RENESAS TECHNICAL UPDATE

Product Category	MPU&MCU		Document No.	TN-H8*-A403A/E	Rev.	1.00
Title	Correction of errors in the H8SX/1650 Group Hardware Manual		Information Category	Technical Notification		
Applicable Product	H8SX/1650 Group	Lot No.	Reference Document	H8SX/1650 Group Hardware Manual (REJ09B0311-0200)		
		All lots

(1) Page 218, DTCER description in figure 7.1

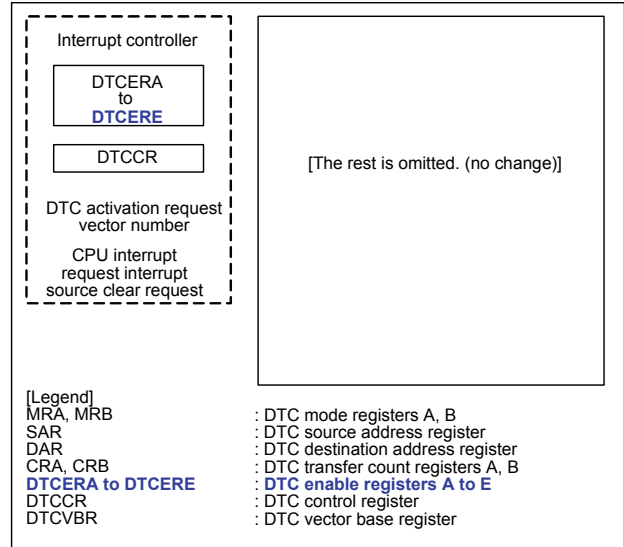
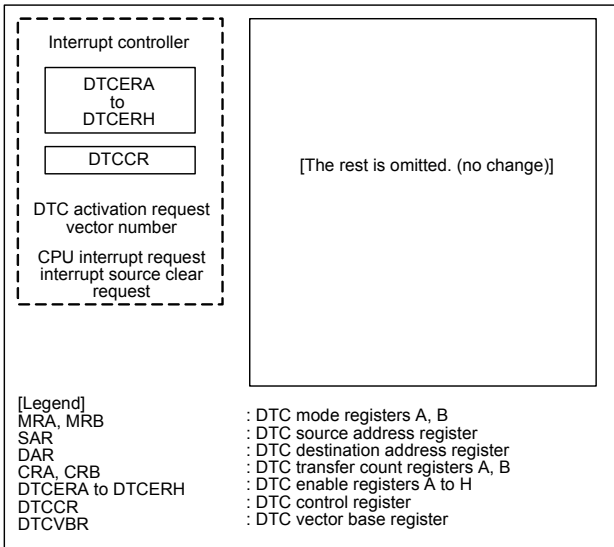
Deletion of DTCERF, DTCERG, and DTCERH in DTCER

[Before Change]

[After Change]
